# Access Compliance Report

## Public Rights-of-Way

Intersection ID: 25995	Main Street: WEDDINGTON_RD	Cross Street: PLANTATION_CENTER_DR	Location: NW
ADA ID: C36F46EF2C91	Ramp Type: Para	Initial Pass/Fail: Fail	Overall Compliance: No
		Severity Score: 12.5

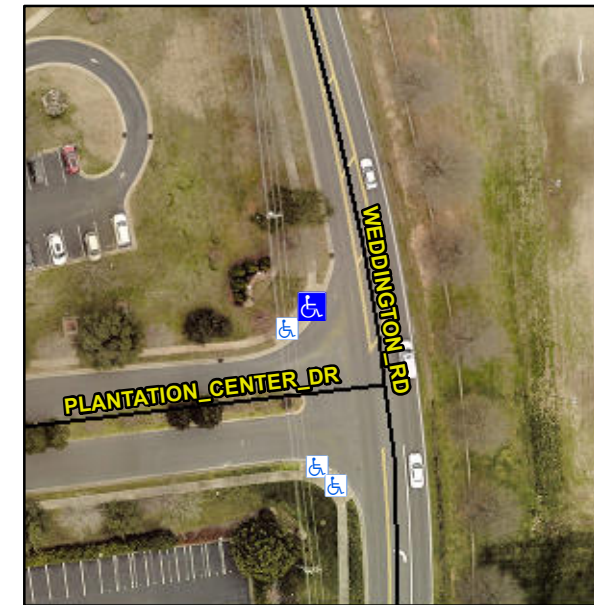
**R304.3.2**

Compliance	Description	Data	Compliance	Description	Data
N/A	Ramp Length LT (in)	60.0	N/A	Ramp Length RT (in)	68.0
Yes	Ramp Width LT (in)	96.0	Yes	Ramp Width RT (in)	96.0
No	Ramp Slope LT (%)	8.7	No	Ramp Slope RT (%)	9.4
Yes	Ramp XSlope LT (%)	1.4	Yes	Ramp XSlope RT (%)	1.6
N/A	Landing Length (in)	N/A	N/A	DWS Provided?	N/A
N/A	Landing Width (in)	N/A	N/A	DWS Contrast?	N/A
N/A	Landing Slope (%)	N/A	N/A	DWS Length (in)	N/A
N/A	Landing X Slope (%)	N/A	N/A	DWS Full Width?	N/A
N/A	Landing Curb? (Y/N)	N/A	N/A	DWS Offset (in)	N/A
N/A	Shared Landing?	N/A			
N/A	Gutter Ponding?	N/A	N/A	Gutter Slope (%)	N/A
N/A	Gutter Lip Ht (in)	N/A	N/A	Gutter X Slope (%)	N/A
N/A	Painted X Walk1?	No	N/A	Painted X Walk2?	N/A
	X Walk 1 Direction	To NE		X Walk 2 Direction	N/A
N/A	X Walk 1 Width (in)	N/A	N/A	X Walk 2 Width (in)	N/A
	X Walk 1 Slope (%)	0.7		X Walk 2 Slope (%)	N/A
	X Walk 1 X Slope (%)	1.2		X Walk 2 X Slope (%)	N/A
N/A	Ramp inside XWalk1?	N/A	N/A	Ramp inside XWalk2?	N/A

**Remove & Replace Entire Ramp.**
